**RE: QUOTE FOR PAINTING THE FIRST FLOOR INTERIOR OF
CENTRAL FIRE STATION**

RE: CLARIFICATION/ADDENDUM #1

**THIS IS CLARIFICATIONS/ADDENDUM ON THE QUOTE FOR PAINTING THE FIRST FLOOR
INTERIOR OF CENTRAL FIRE STATION**

1 LOWER FLOOR PLAN
SCALE: 1/8" = 1'-0"

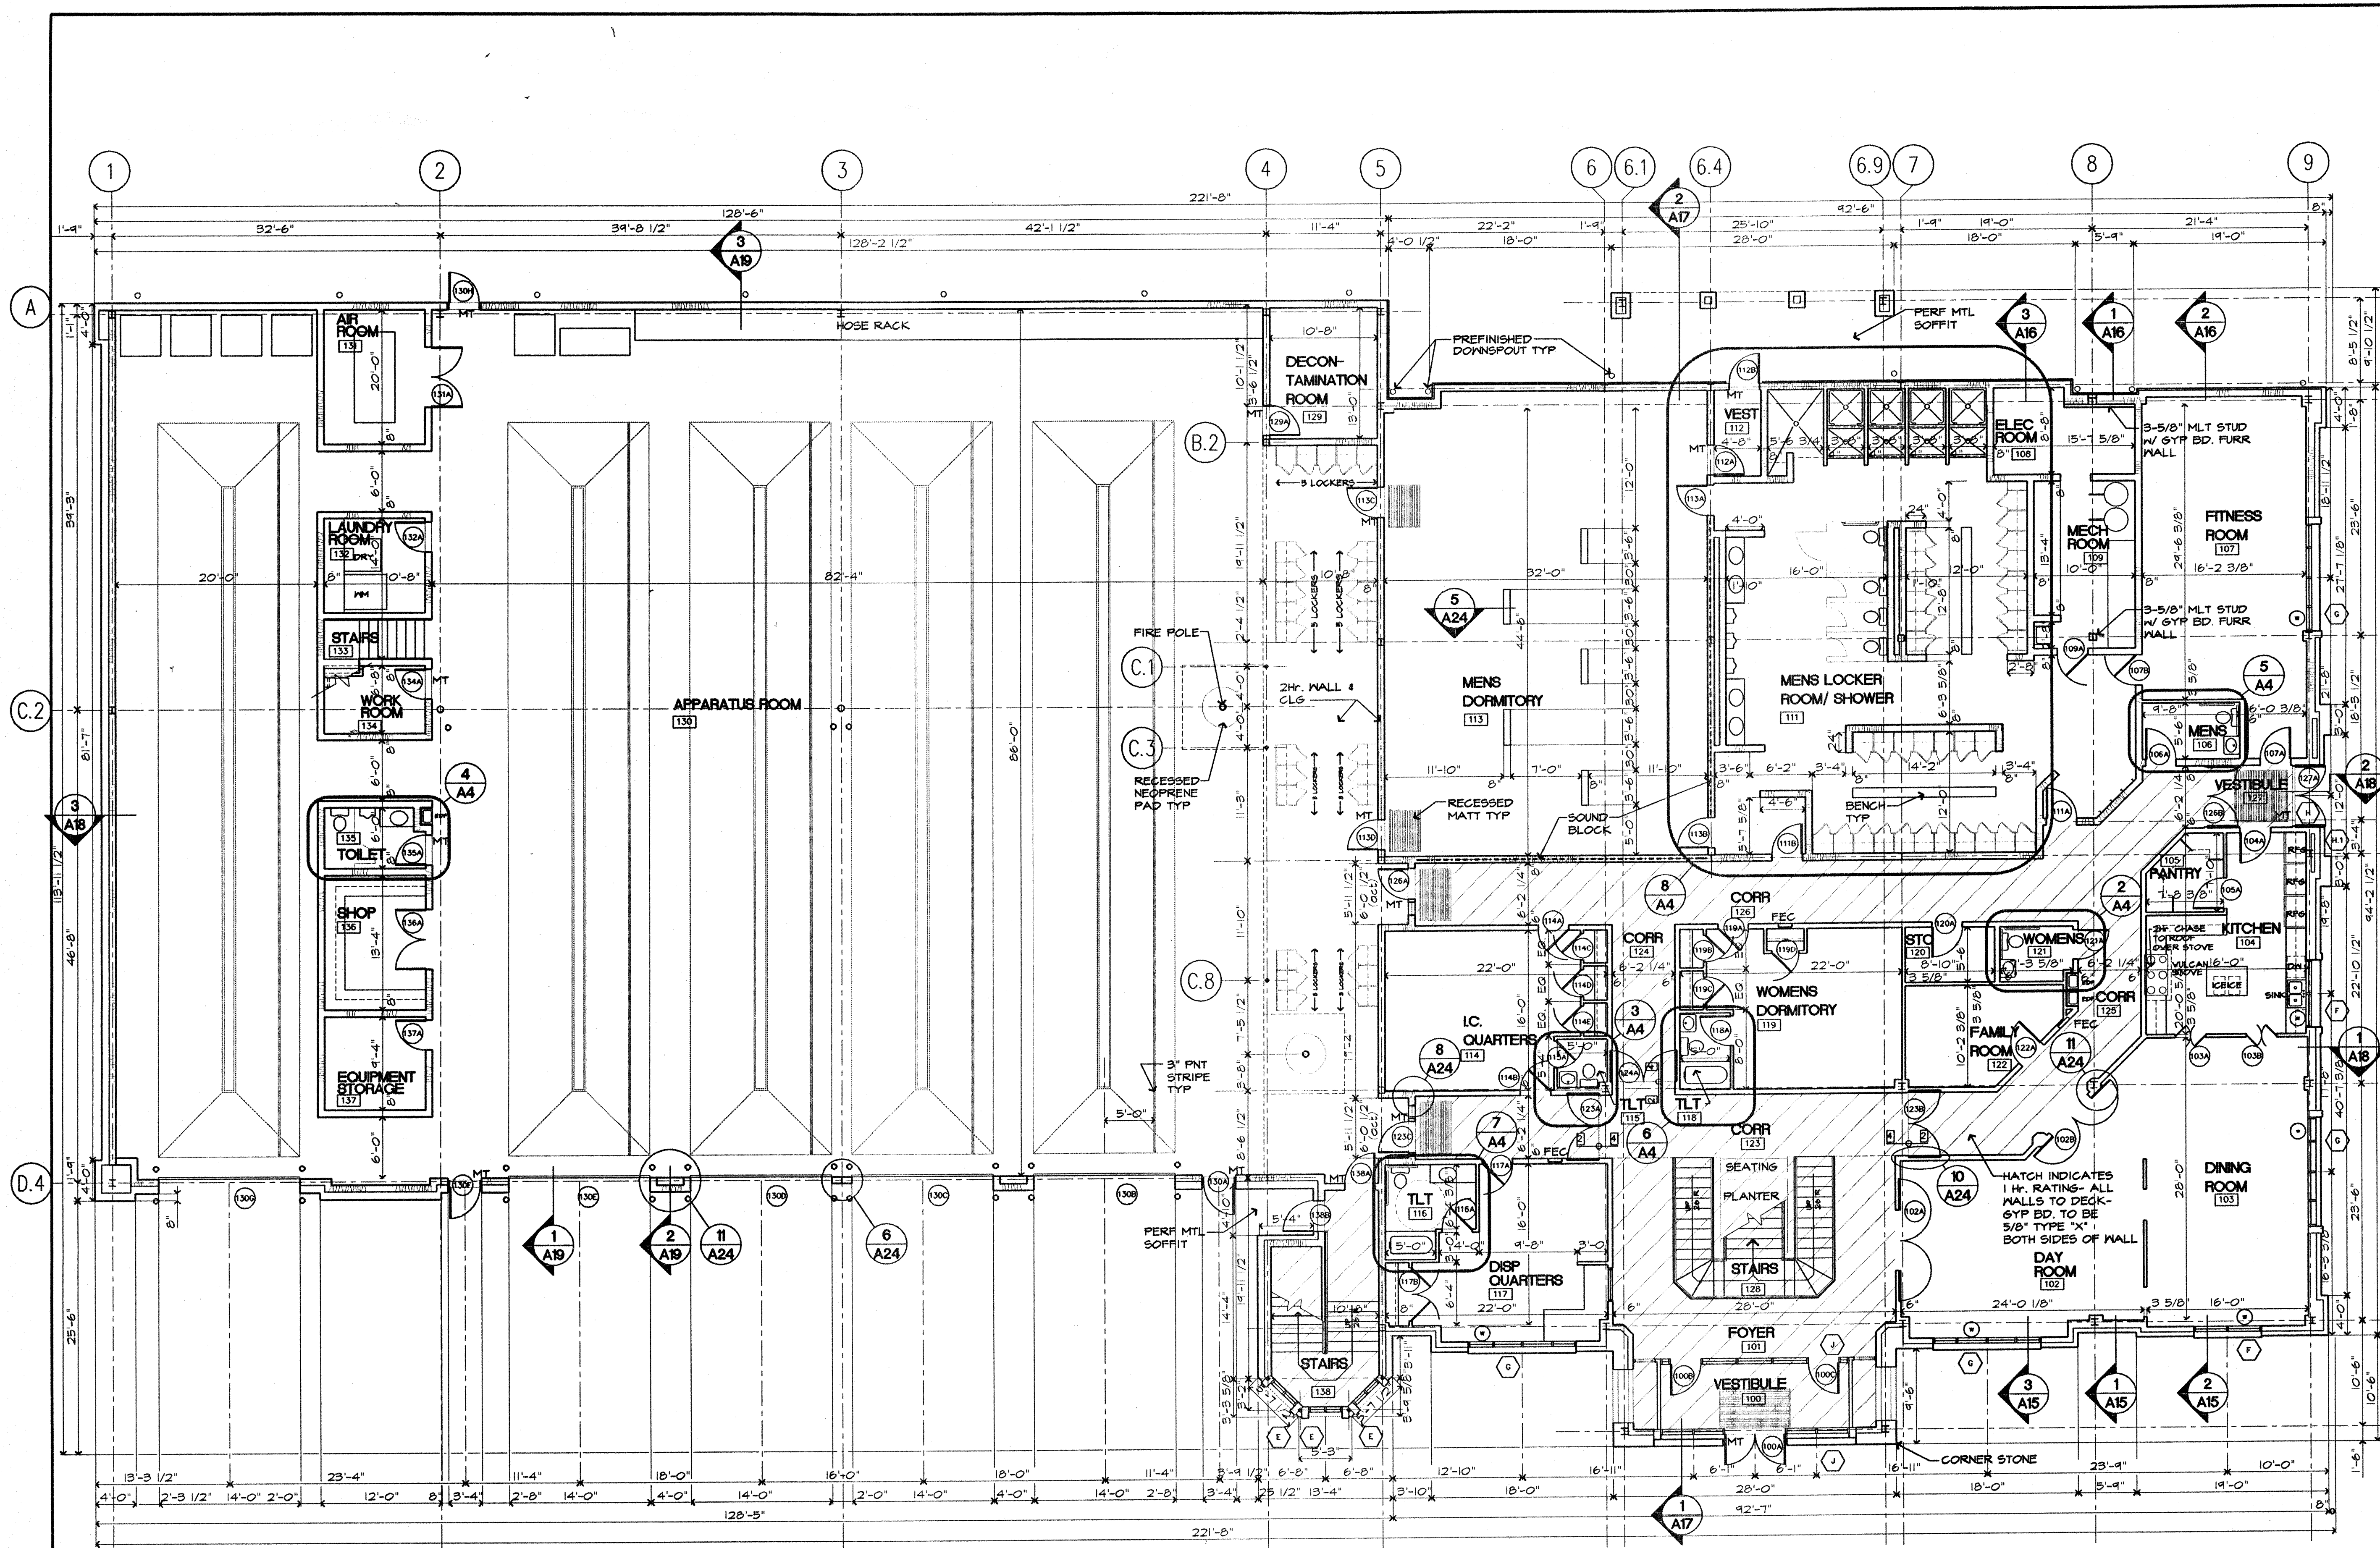
- New bid form to be completed.:
 - 1) Price for tearing off existing wallpaper, cove base where applicable, and painting the walls.
 - 2) Price for only cove base where applicable and painting the walls.
- ONLY painting block wall in Dispatch. Don't paint any of the other block walls in the station.
- Attached are the floor plans for the 1st floor.
